P-907 Answers to PAC questions

Figure 1: Ring radius distributions for interaction data for tracks with 95 – 105 GeV/c momentum. Very well separated peaks corresponding to pions (right) and kaons (left) can be seen.

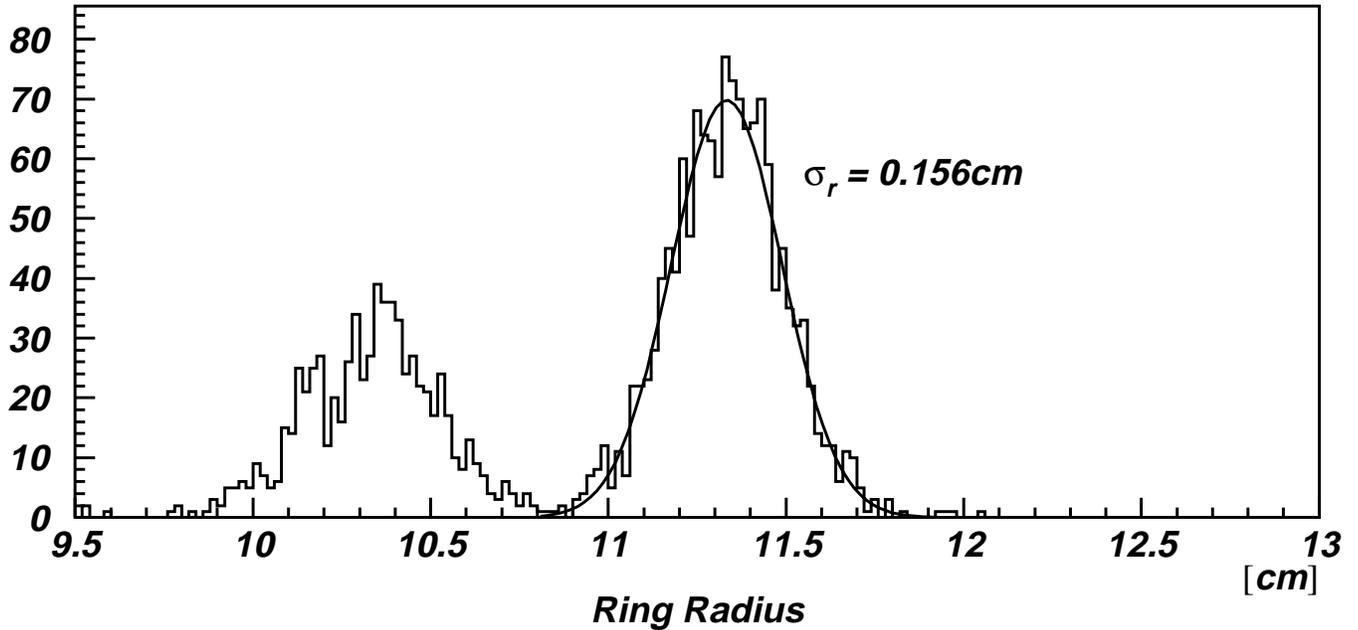
The third source of systematic error for MINOS comes from particle mis-identification. i.e. how often do pions get identified as Kaons. Figure 1 shows the ring-radius distribution for pions and kaons (lower ring radii) for the SELEX RICH counter (J.Engelfried et al, Fermilab-Pub-98/299E, submitted to NIM A) for 95 GeV/c-105 GeV/c momentum. The separation between pions and Kaons

is excellent and SELEX estimates a mis-identification rate of 4% for pion to fake a proton or kaon. The systematic error in this measurement is introduced by the error on the 4%. It should be possible to determine the fake probability to 2% or so using again Λ 's and K^0 's, given enough statistics, yielding a systematic error per pion of $8E-4$. This should then be folded into the Monte Carlo to yield an overall systematic error from this source, but already one can see that it is likely to be negligible for MINOS needs.

Figure 4: NuMI Low Energy Beam Configuration

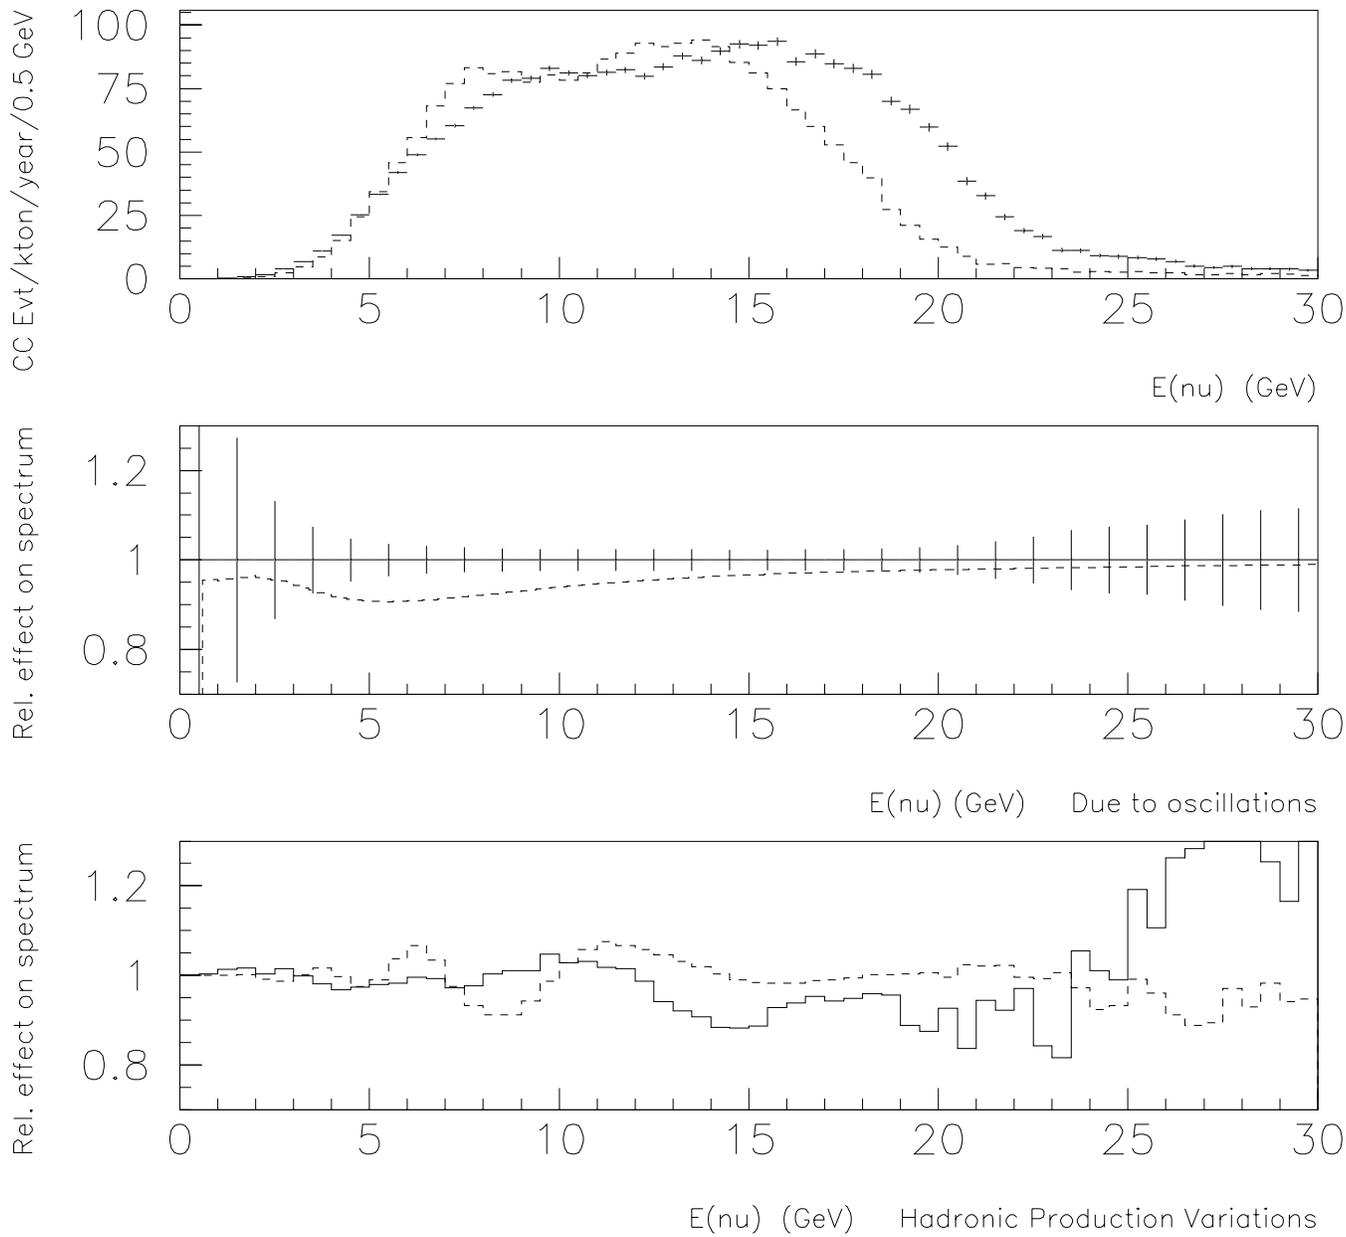
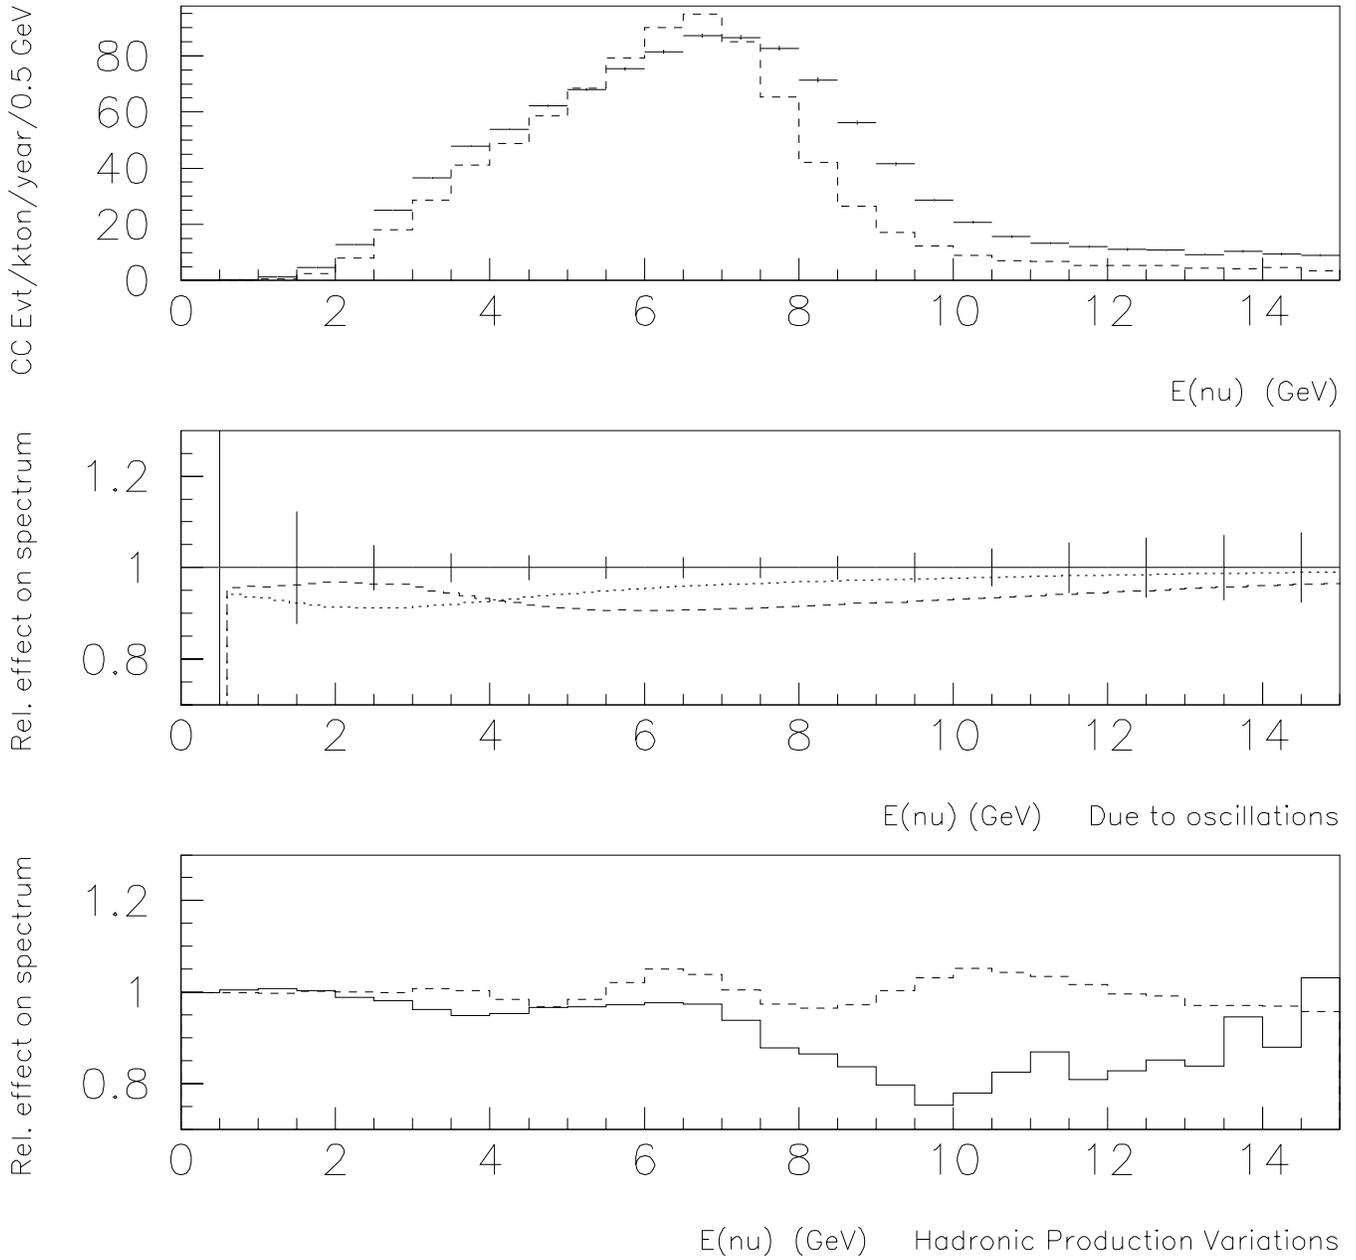
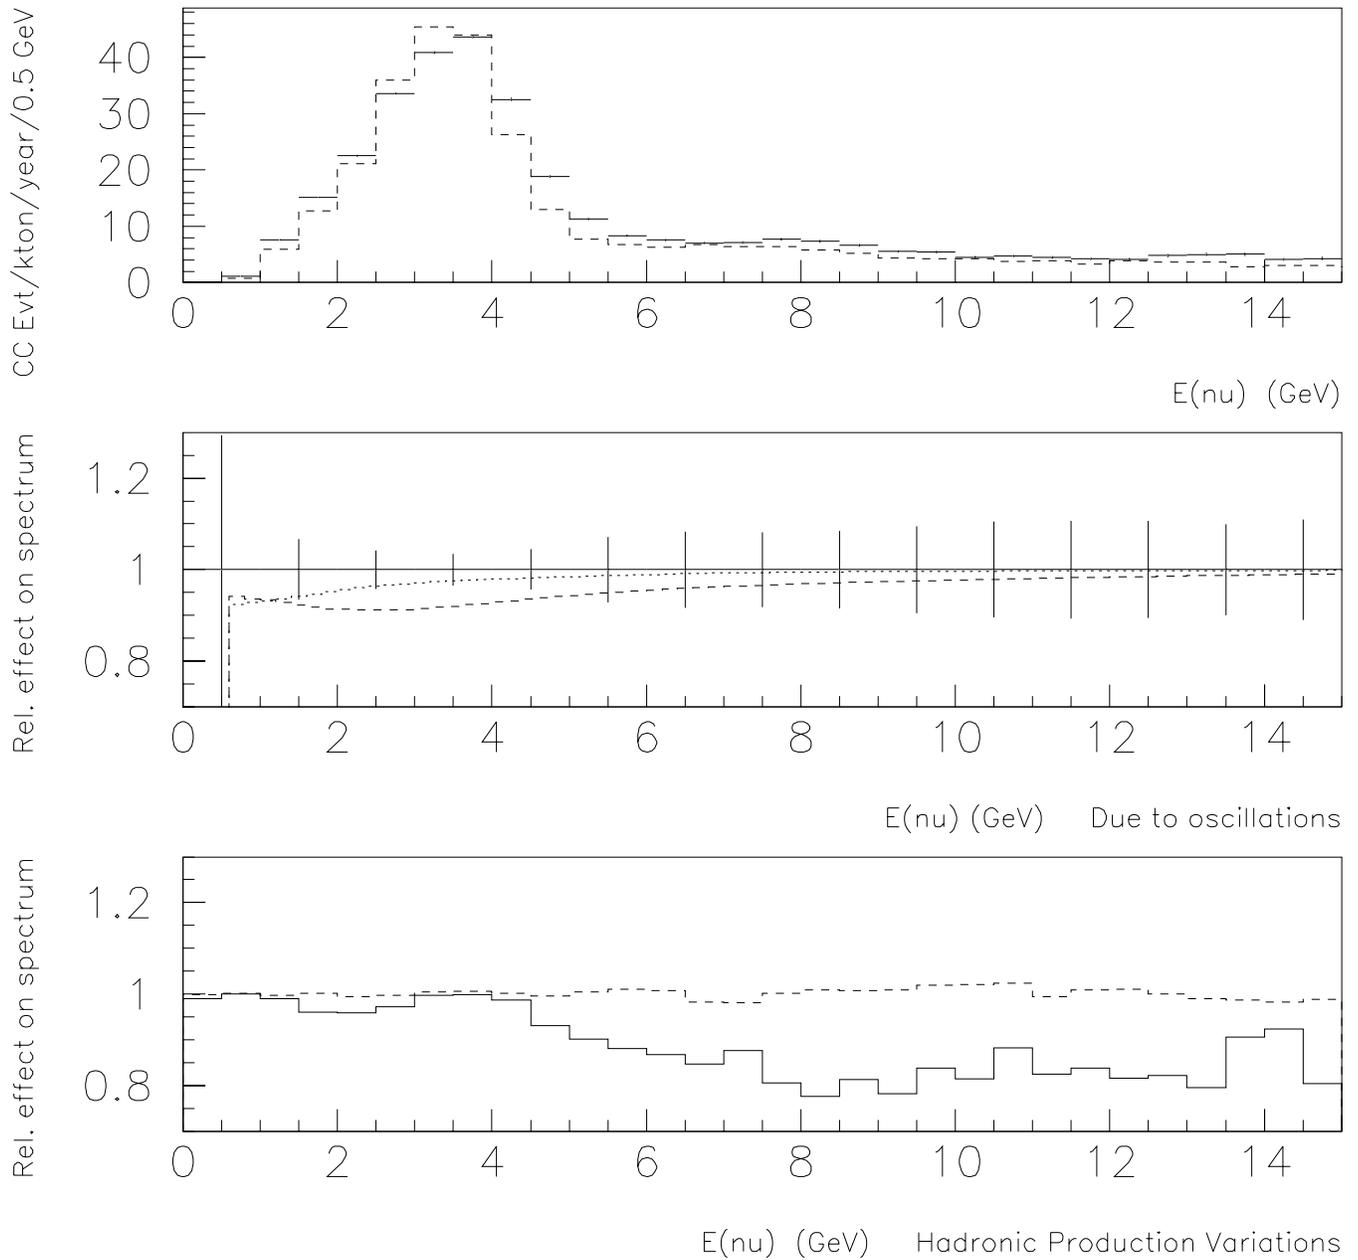
5. Compare the impact of the hadron-spectrum measurement on establishing the far detector to near detector neutrino-flux ratios for the three neutrino beams being planned for MINOS. The Committee notes that p. 32 (Conclusions) of the presentation to the PAC states that knowledge of the hadron spectrum is even more important for the low beam energy configuration.

Figure 2 indicates the sensitivity of the high energy beam configurations to the hadronic production uncertainty, Figure 3 shows the same for the medium energy (baseline) configuration, and Figure 4 shows the low energy configuration.

In general one sees that the Near/Far ratio is less sensitive to hadronic production variations at low energy. Furthermore, the statistical power of the event sample for the low energy configuration is not as good. Hence the improvement to the MINOS experiment given by the hadronic production measurement would be less in the case of the low energy beam. However, one sees that for both the medium and high energy cases the P907 measurement would substantially improve the ability to measure the neutrino oscillation spectrum, and hence make a precision measurement of the oscillation parameters.

P-907 Comments on remark on page 32 of PAC presentation- It can be seen from Figure 4 that the low energy spectrum *is* subjected to distortions from particle production uncertainties. Further, low energy particles have enhanced contribution from secondary interactions in the target which will thus have cumulative error contributions from Geant/Fluka cross section and multiplicity assumptions. This contribution is not estimated by changing the p_T spectrum of the pions, as in the current analysis. It turns out however that the distortions are in a region of neutrino energy that MINOS is insensitive to for the low energy run.
